# Access Compliance Report

## Public Rights-of-Way

### (Curb Ramps)

Intersection ID: 23730	Main Street: PROVIDENCE_RD	Cross Street: CEDAR_CROFT_DR	Location: SW
ADA ID: 04A6E08670C8	Ramp Type: Perp	Initial Pass/Fail: Fail	Overall Compliance: No
Severity Score: 42.5			
Codes/Mitigation Info/Possible Solution		Field Measurements/Component Compliance

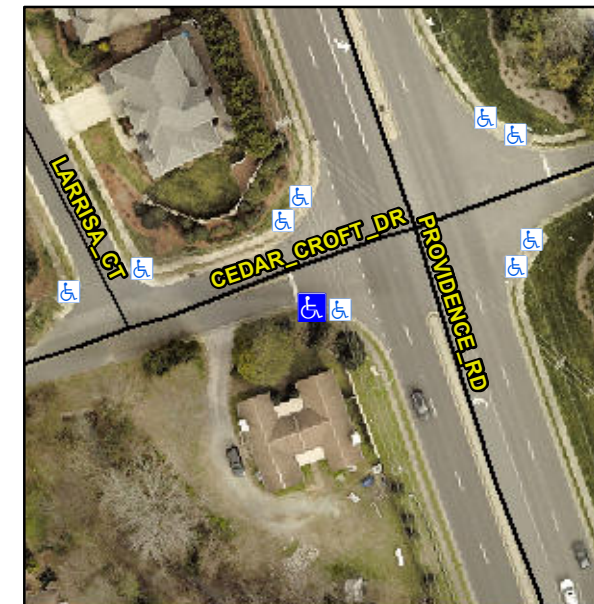
**R304.5.1, R304.2.2, R304.5.3**

Compliance	Description	Data	Compliance	Description	Data
N/A	Ramp Length (in)	71.0	No	Ramp Slope (%)	10.9
No	Ramp Width (in)	34.0	No	Ramp XSlope (%)	5.6
N/A	Flare Type LT	N/A	N/A	Flare Type RT	N/A
N/A	Flare Slope LT (%)	N/A	N/A	Flare Slope RT (%)	N/A
N/A	Flare Traversable LT?	N/A	N/A	Flare Traversable RT?	N/A
N/A	Landing Length (in)	N/A	N/A	DWS Provided?	N/A
N/A	Landing Width (in)	N/A	N/A	DWS Contrast?	N/A
N/A	Landing Slope (%)	N/A	N/A	DWS Length (in)	N/A
N/A	Landing X Slope (%)	N/A	N/A	DWS Full Width?	N/A
N/A	Landing Curb? (Y/N)	N/A	N/A	DWS Offset (in)	N/A
N/A	Shared Landing?	N/A			
N/A	Gutter Ponding?	N/A	N/A	Gutter Slope (%)	N/A
N/A	Gutter Lip Ht (in)	N/A	N/A	Gutter X Slope (%)	N/A
N/A	Painted X Walk1?	No	N/A	Painted X Walk2?	N/A
	X Walk 1 Direction	To NW		X Walk 2 Direction	N/A
N/A	X Walk 1 Width (in)	N/A	N/A	X Walk 2 Width (in)	N/A
	X Walk 1 Slope (%)	4.6		X Walk 2 Slope (%)	N/A
	X Walk 1 X Slope (%)	7.3		X Walk 2 X Slope (%)	N/A

**Remove & Replace Entire Ramp.**
